WATERLOO METRO QUARTER BUILDING 3&4

SSD-10437 - RESPONSE TO SUBMISSIONS
SUPPLEMENTARY DESIGN REPORT

PREPARED FOR WATERLOO DEVELOPER PTY LTD
DOCUMENT NO. WMQ-BLD34-BSA-AR-RPT-DA210

Revision A

**Building 4 Communal Roof Terrace
PROPOSED**

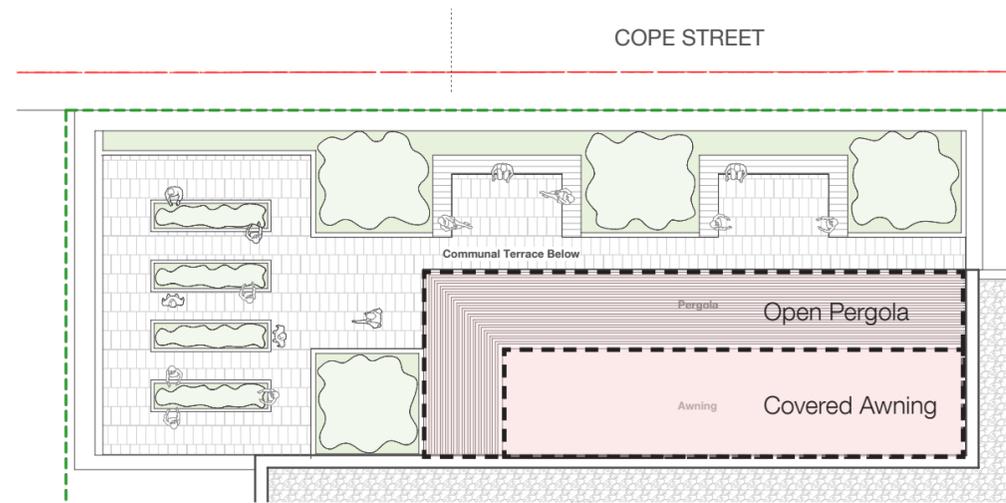
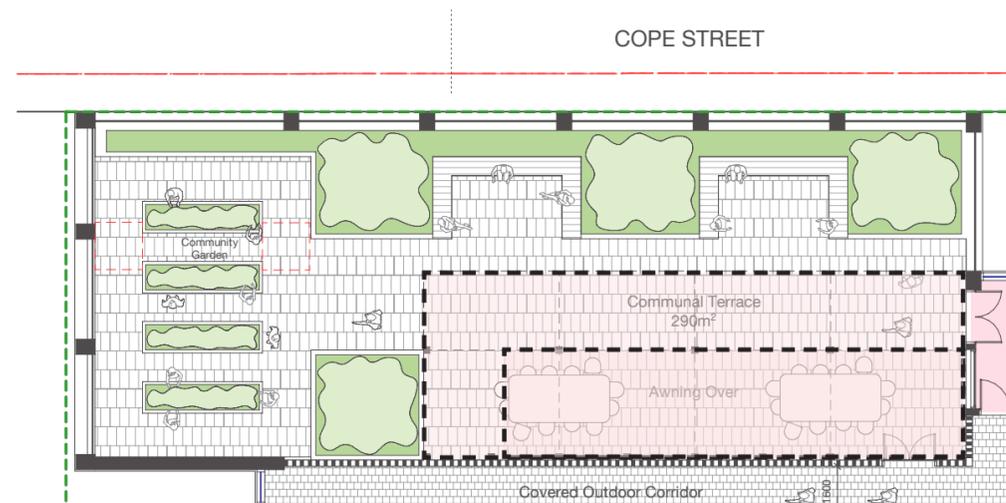
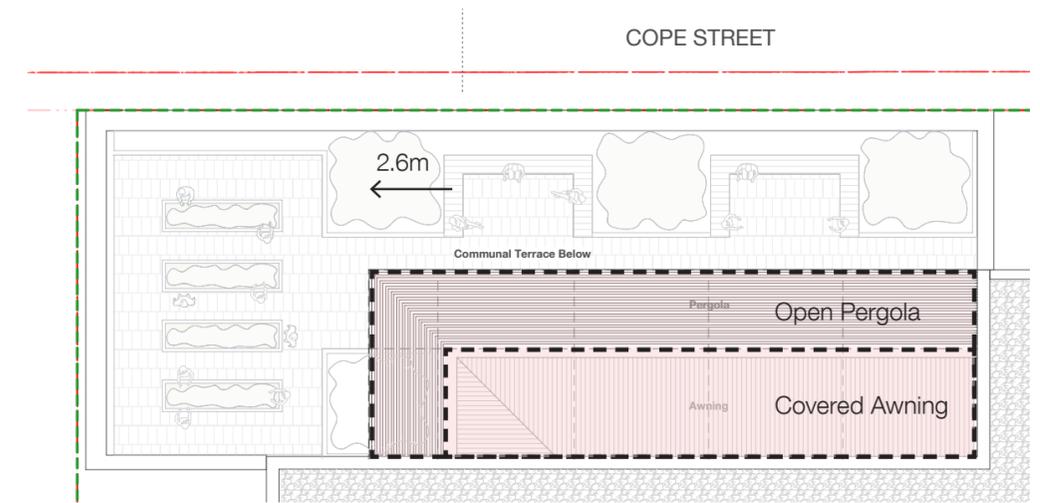
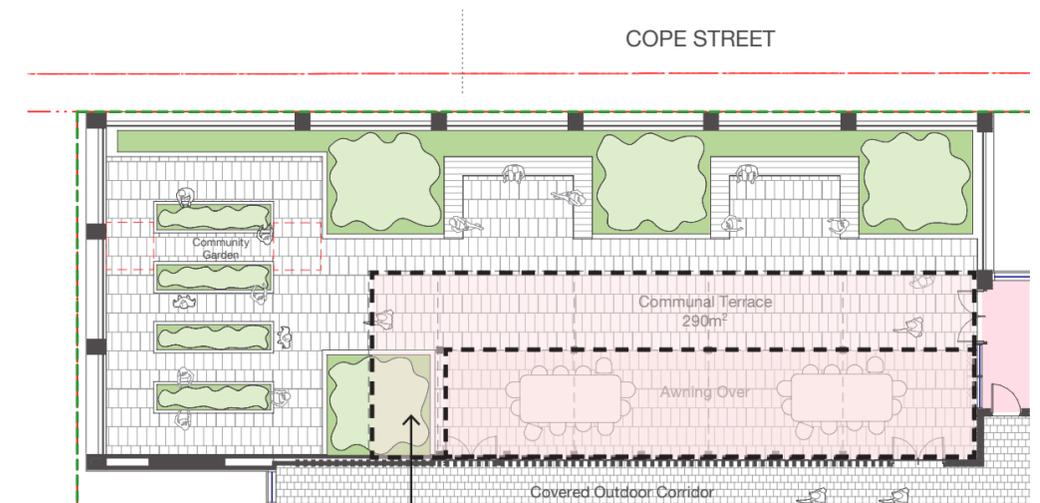
Whilst item 25 relates solely to the Building 3 terrace, we have also reviewed the design of the pergola/awning structure to the communal roof terrace on Building 4. The pergola has been extended 2.6m to the north to further improve the wind conditions for residents.

Pergola extended north by approx. 2.6m to further improve wind conditions on the communal terrace

Building 3 east elevation

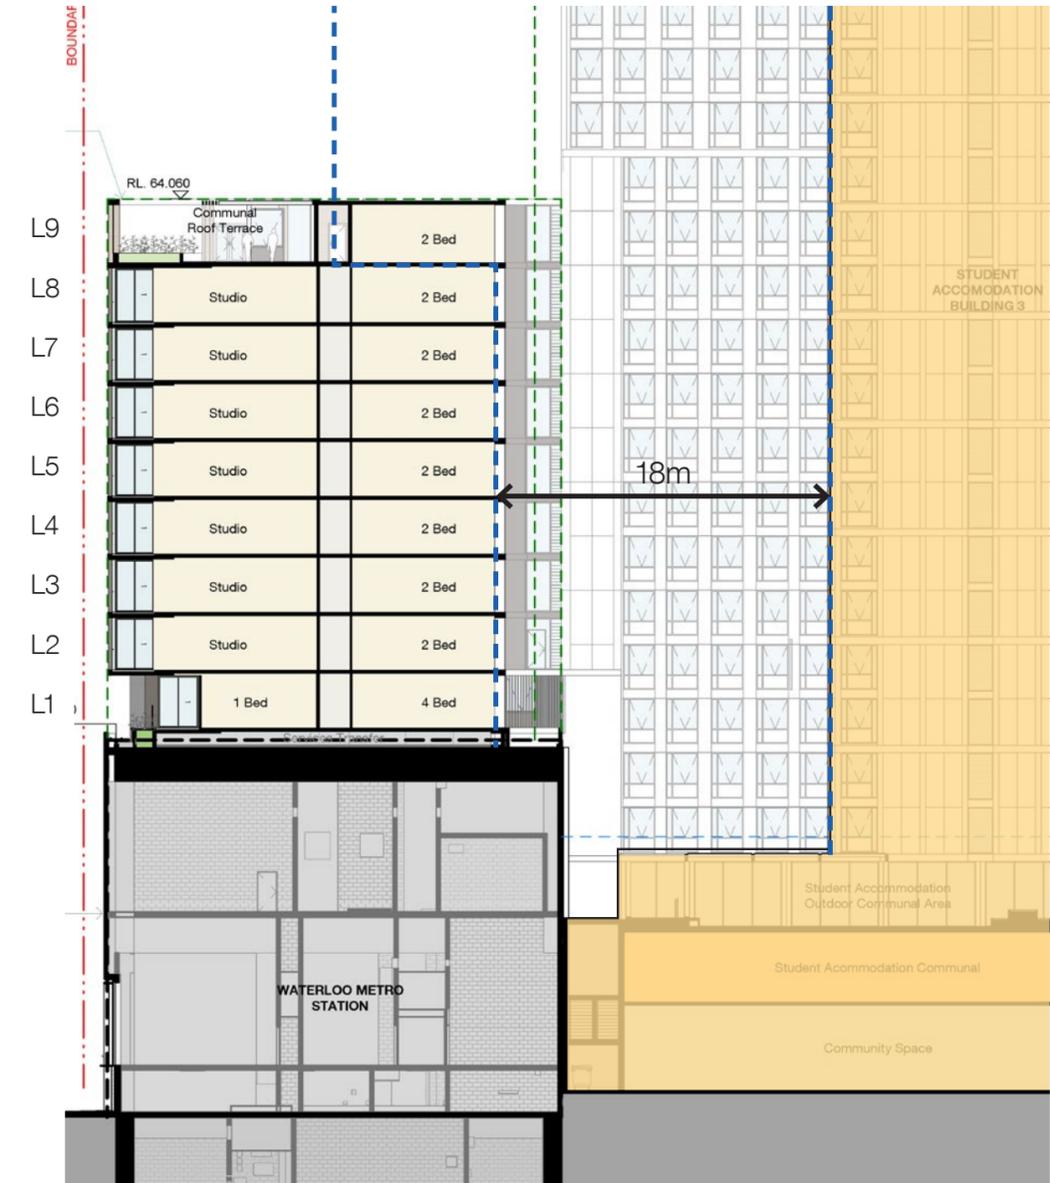
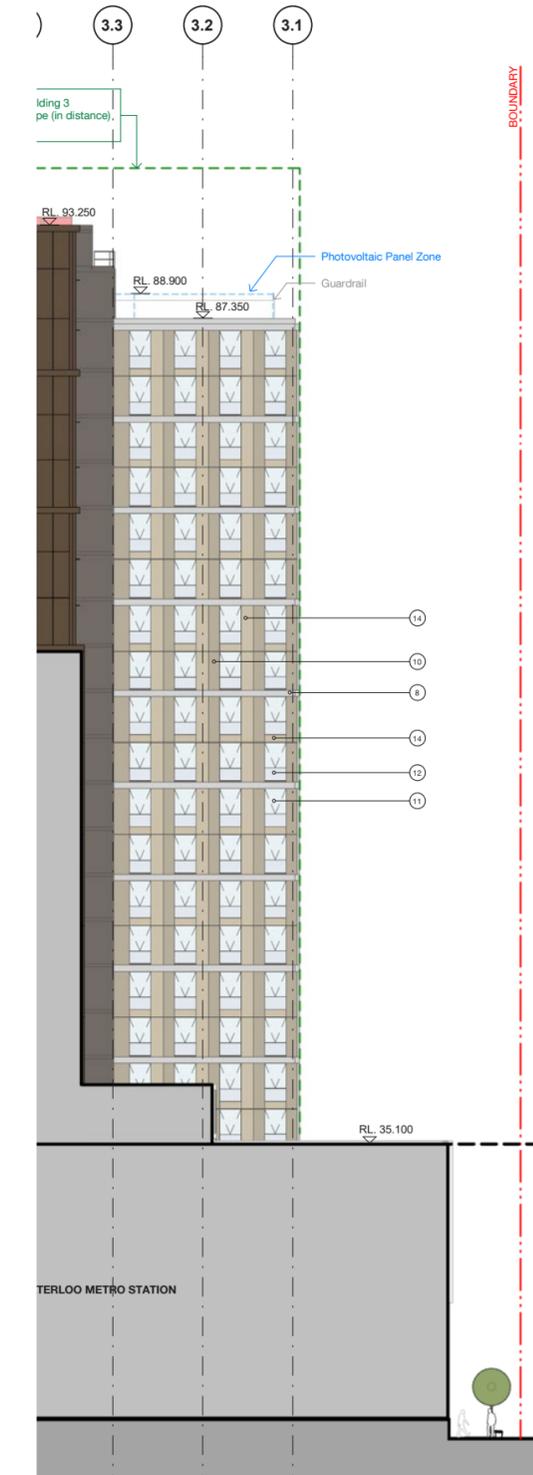
Insufficient building separation and visual privacy is provided between the west facing social housing apartments and east facing boarding rooms pursuant to Objectives 2F and 3F of the ADG. The proposed privacy screens to the boarding rooms are inadequate to mitigate overlooking and ensure sufficient amenity to residents. An alternative design solution is required. For example, the boarding rooms could be provided bay windows with glazing oriented towards the north and either a solid wall or similar obscuring material presented to residents of the affected social housing units.

/ Glazing to bedrooms is limited to a single window that is 1.05m wide with 0.8m high solid spandrels. Bedroom windows are also located in the corner of the rooms to limit view angles

/ Perforated aluminium balustrades provide further visual privacy to the west facing balcony

/ Providing a high level of facade depth and solidity on the western facade through the use of projecting horizontal slab edges, vertical brick piers and spandrels to windows helps restricts oblique views from floors above and below

/ Angled privacy screens to the Building 3 facade help to partially obscure the windows to the student accommodation studios.

/ Locating the shared common space to each floor on western side of the floorplate, therefore not overlooking other buildings.

/ Integrated internal roller blinds installed to all studios allowing a degree of user control

The privacy screen covers approx. 21% of the east facing student accommodation windows (when viewed in elevation)

Floorplate Design Response

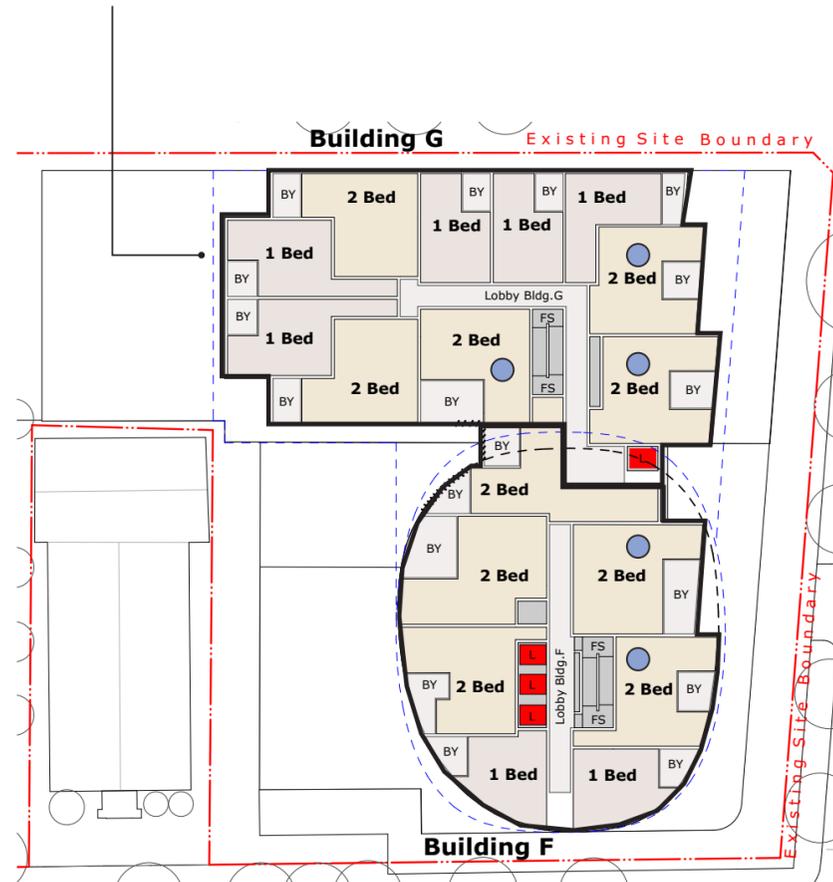
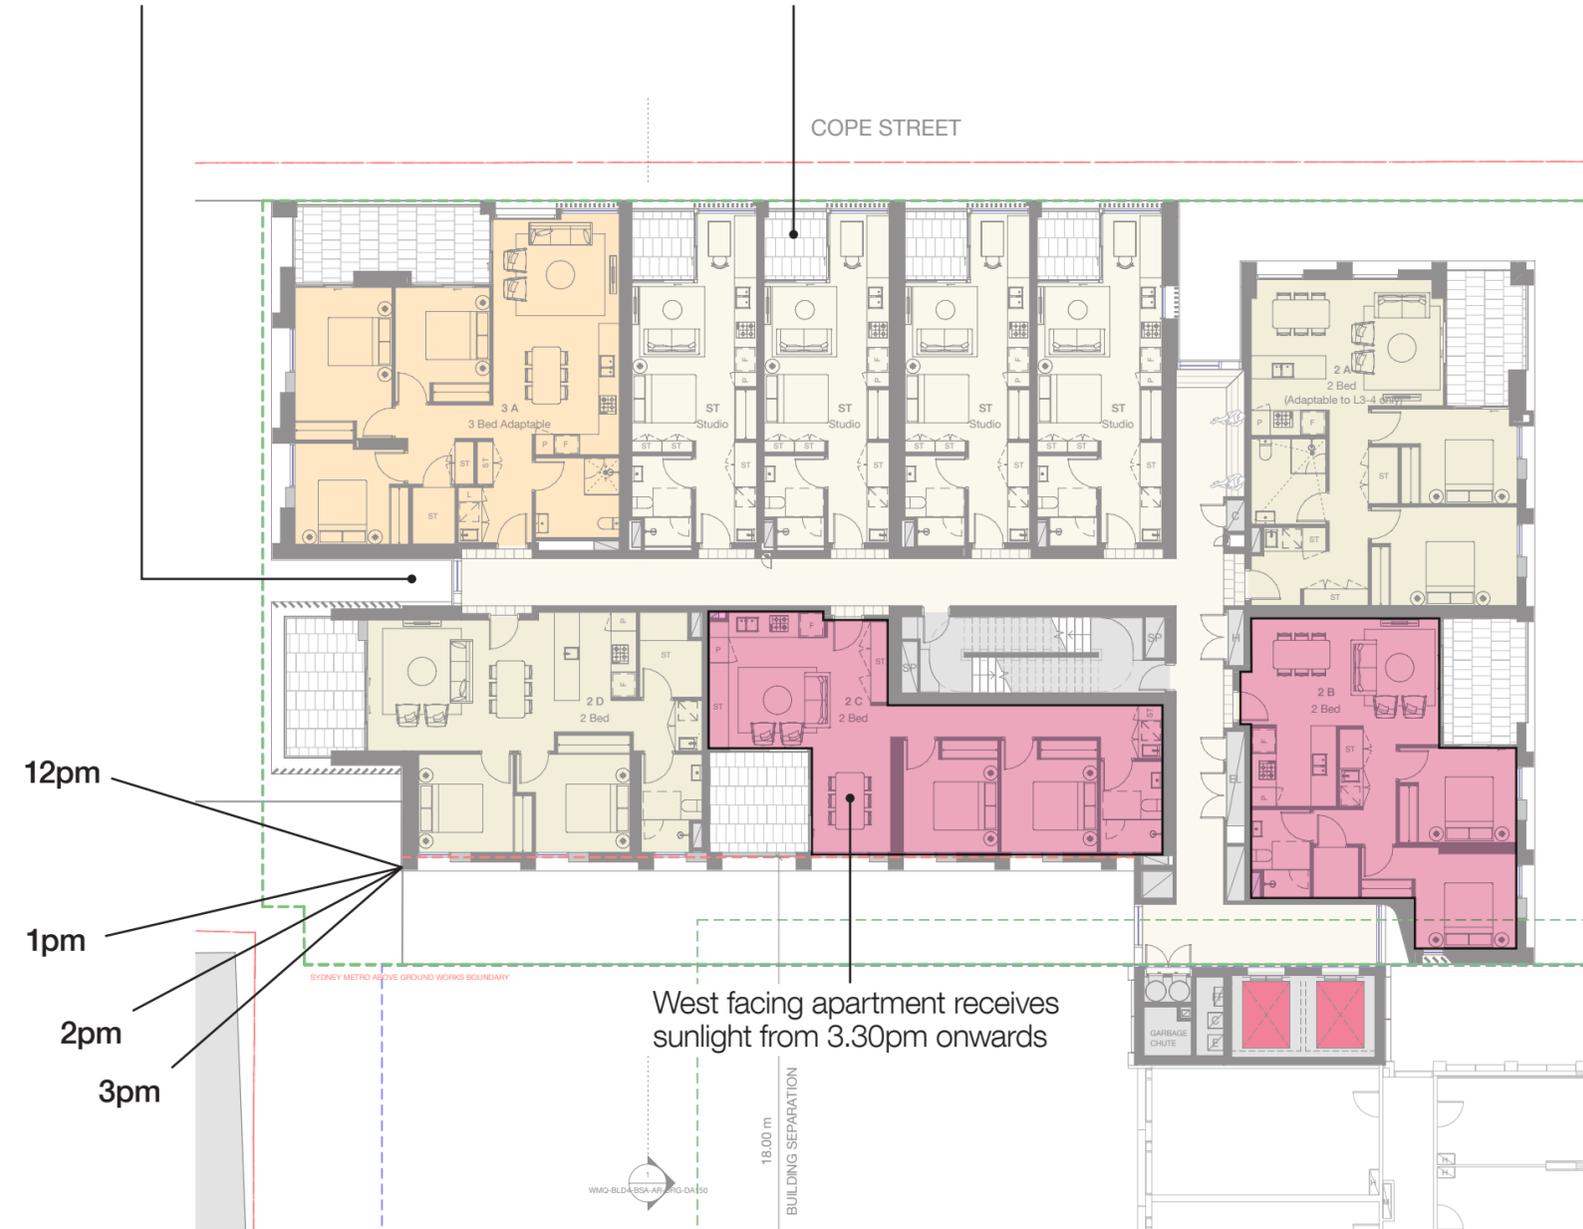
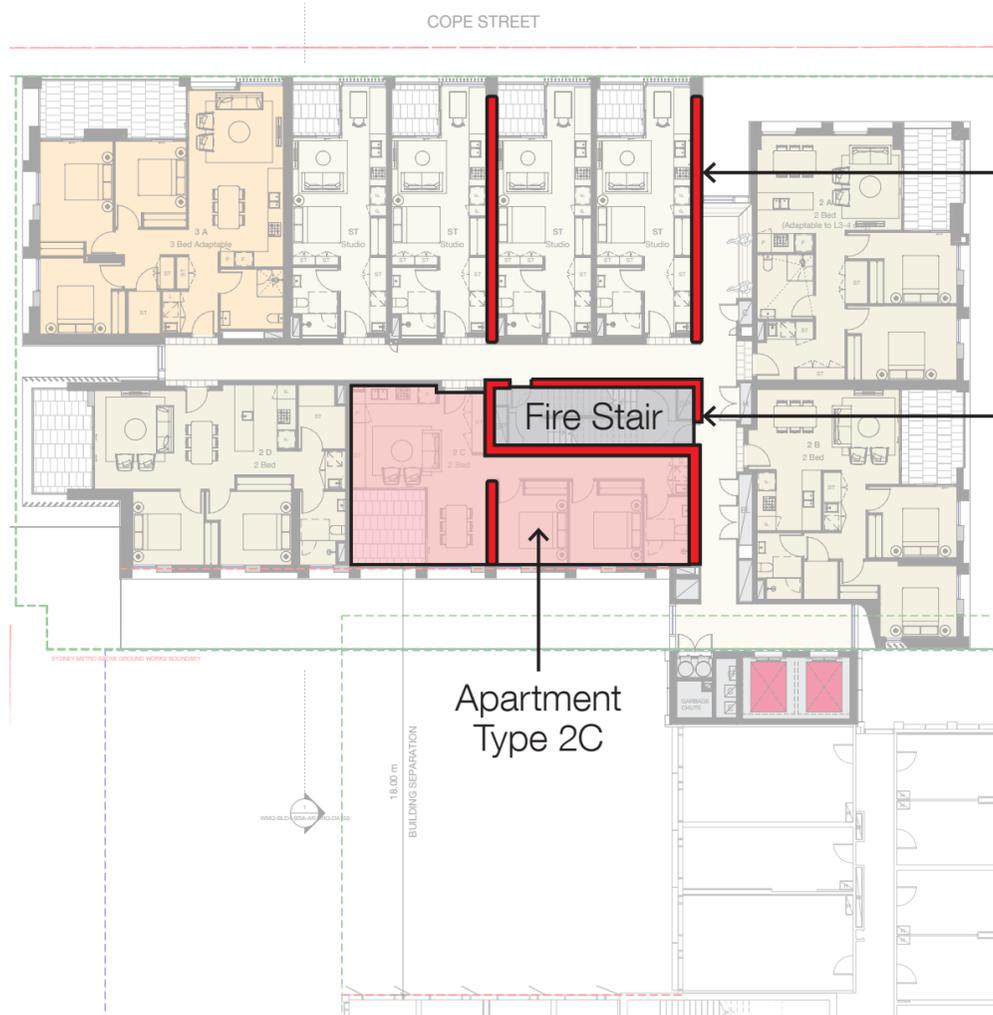
The City notes that 15 of 70 apartments (21%) do not receive any direct solar access during mid-winter, four more than is permitted (15%) in accordance with Objective 4A-1 of the ADG. The City does not support the applicant's justification by including direct sunlight received after 3.00pm as this is not reflected in the design guidance or criteria and is of little thermal benefit due to the low altitude of the sun. Furthermore, some assertions regarding solar access are overstated, for example the quality of solar access to the living room of apartment 106 (the four-bedroom apartment).

The proposed design has 15 of 70 apartments (21%) that do not receive direct solar access during mid-winter. Our response includes an analysis of the envelope constraints that have limited the ability to achieve compliance, as well as our design responses to maximise solar amenity through other design responses.

The Stage 1 DA envelope for Buildings 3 & 4 has a number of constraints that have limited the ability to achieve solar access to Building 4. These constraints include:

/ The envelopes for Building 3 and 4 are located back-to-back in an L-shaped plan, reducing the extent of available facade frontage

/ Solar access to west facing apartments in mid winter is limited by the shadow cast by Building 2 - an inherent limitation of the Stage 1 masterplan. The solar access studies from the Stage 1 DA demonstrate that the west elevation of Building 4 did not receive sunlight between 1pm and 3pm at Mid Winter. As a comparison, the reference scheme had 30% of apartments receiving 0hrs direct sunlight between 9am and 3pm.

/ The location of the core, which is constrained by the station box below, limits the extent of available facade frontage.

- / The east facing volume has been designed to be deeper (than the west facing volume) to maximise apartments on this frontage for solar access
- / The west and south facing volumes have been designed to be shallower to minimise the quantity of apartments in these orientations
- / The quantity of apartments to the south and west has been minimised
- / Whilst outside the hours prescribed under the ADG, we note the solar access analysis shows the west facing apartment receives direct sunlight from 3.30pm onwards at mid winter.

Alternative layouts A and B were considered to re-locate the living space and balcony further south to achieve direct solar access to this apartment in midwinter. However, given the constraints of the envelope, and the required building structure, these alternative layouts did not achieve the desired outcomes for apartment living.
